**STATE OF HAWAII
DEPARTMENT OF TRANSPORTATION
HARBORS**

**ADDENDUM NO. 1
FOR
REPAIR ELEVATOR AT ALOHA TOWER
HONOLULU HARBOR, OAHU, HAWAII
S10842R**

October 11, 2024

2 11TH FLOOR POWER PLAN
 E-5 SCALE: 1/4" = 1'-0"

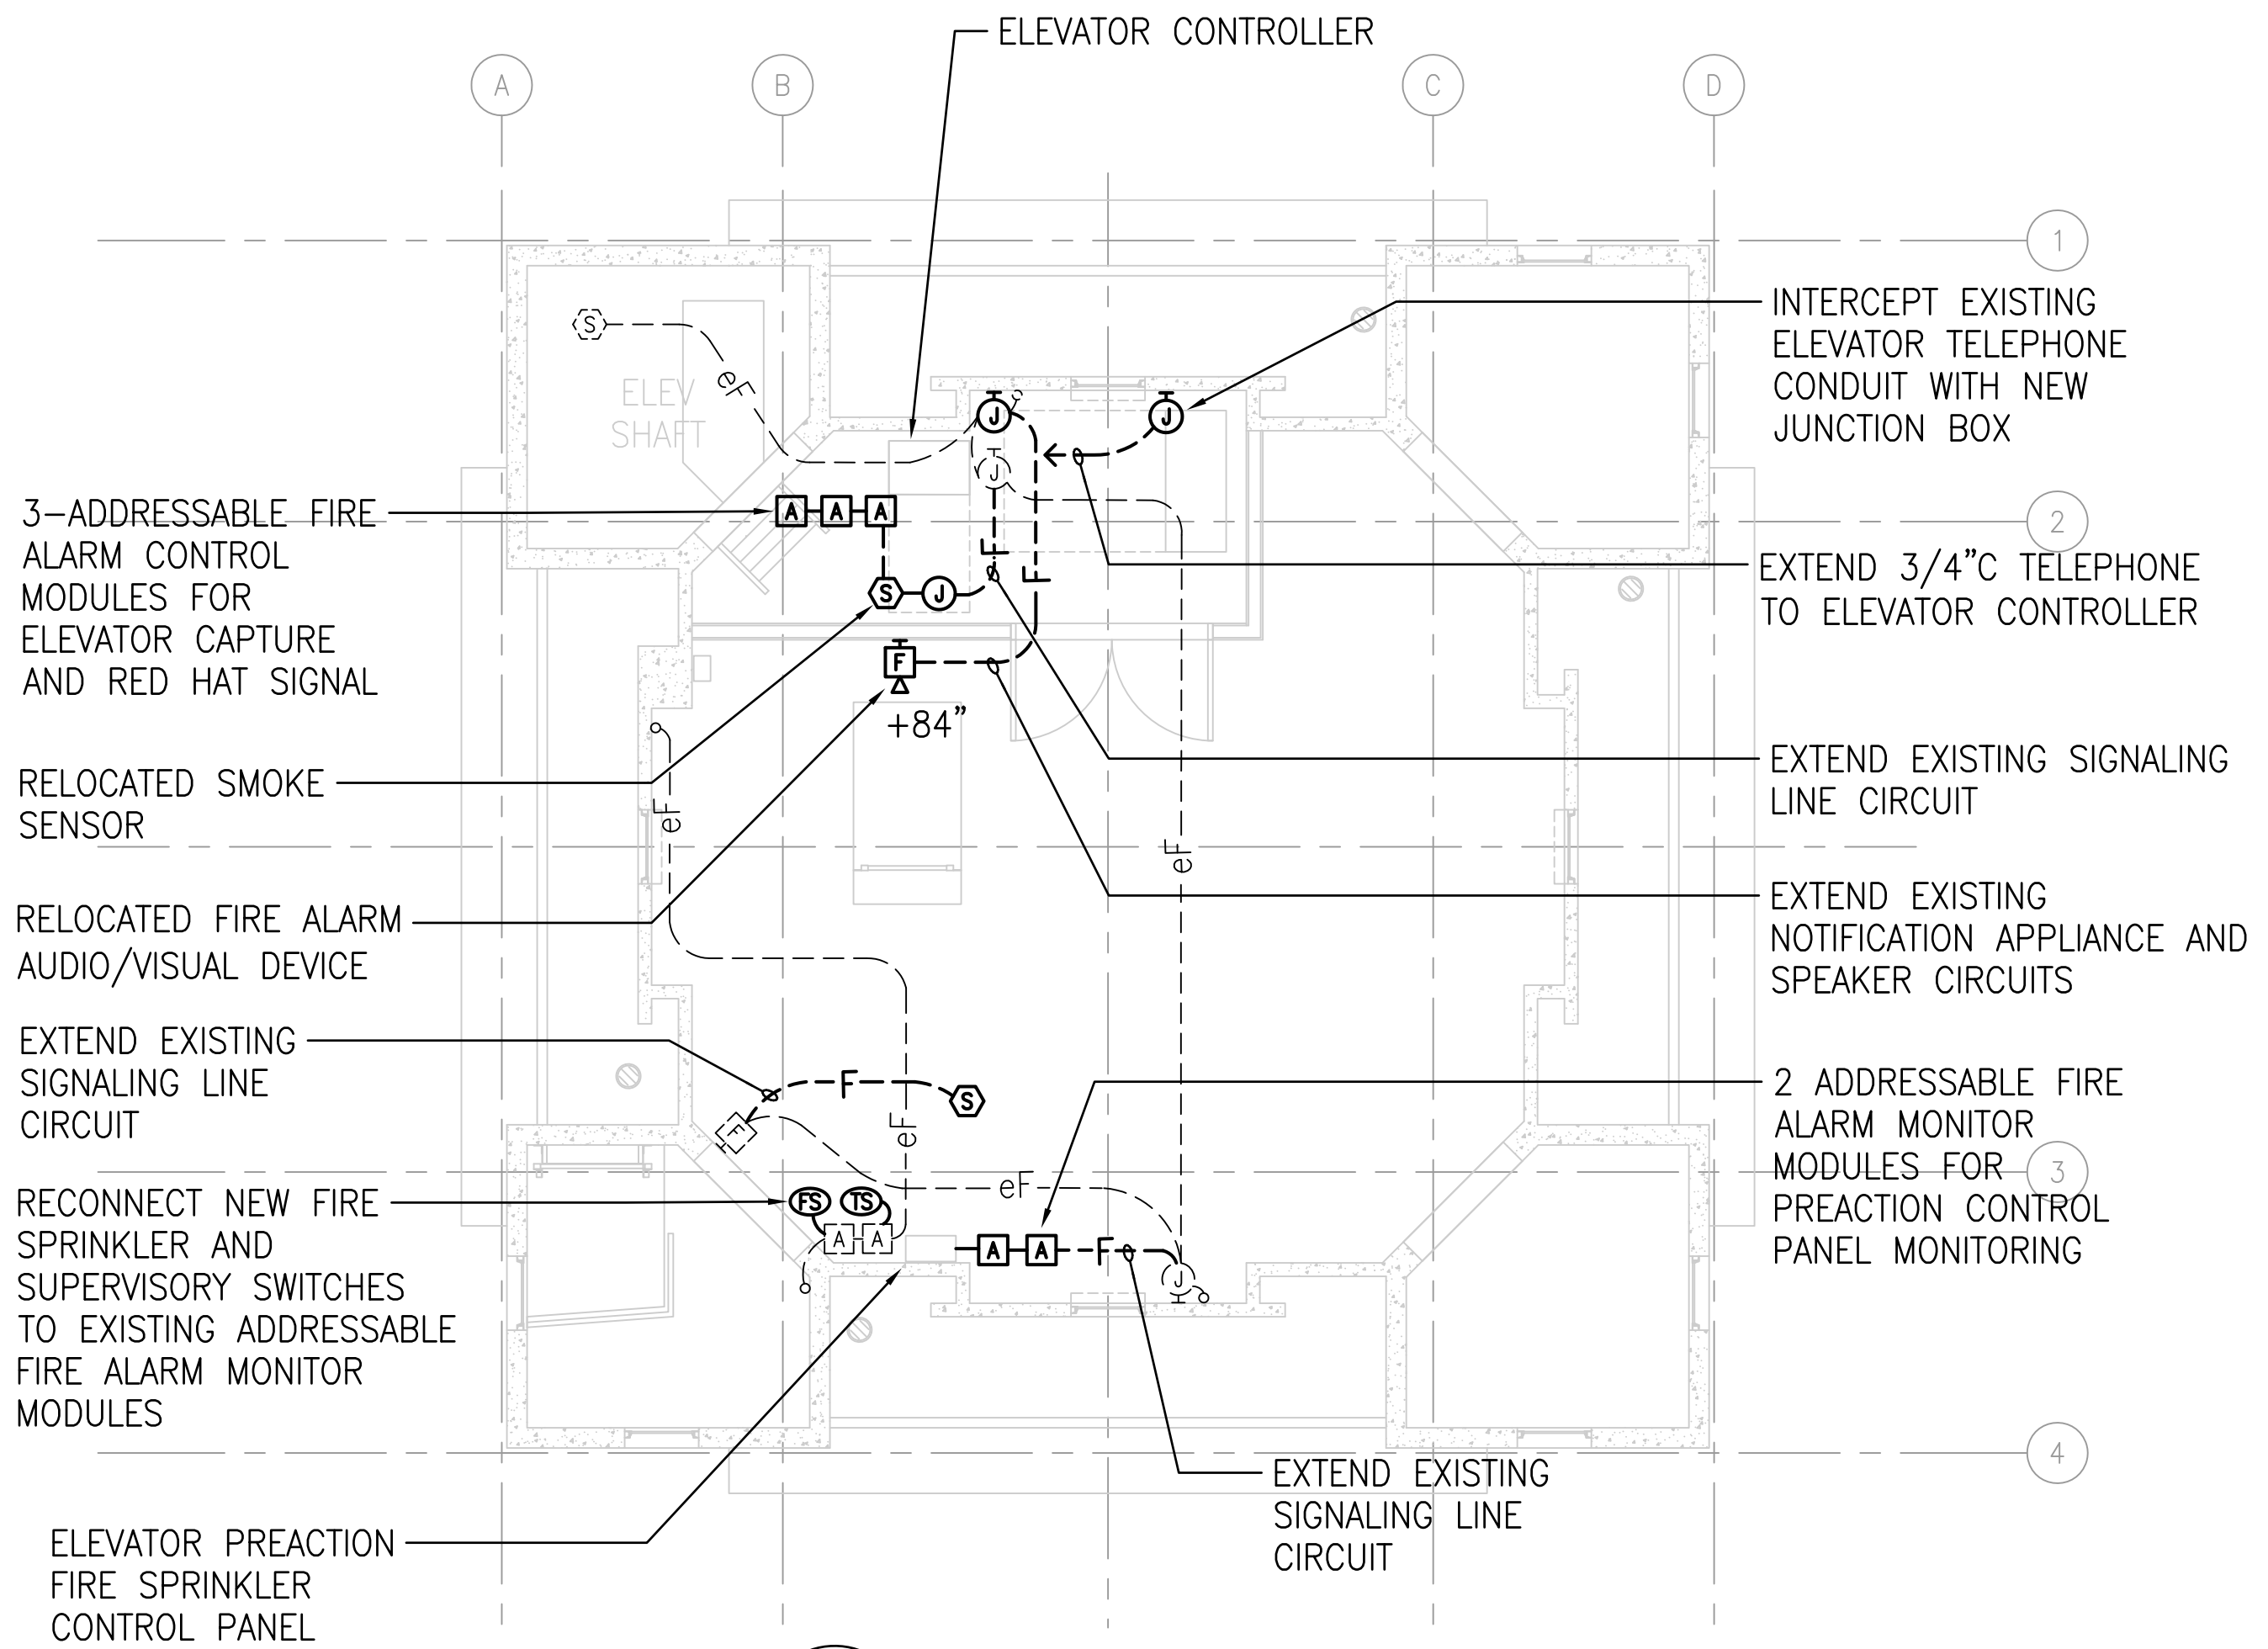
16. Detail 2/E-5 shows a new 3kVA mini-power center EL. One-line diagram detail 1/E-6 shows a 5kVA mini-power center EL. Please clarify.

Response: Mini power center shall be rated 5 KVA.
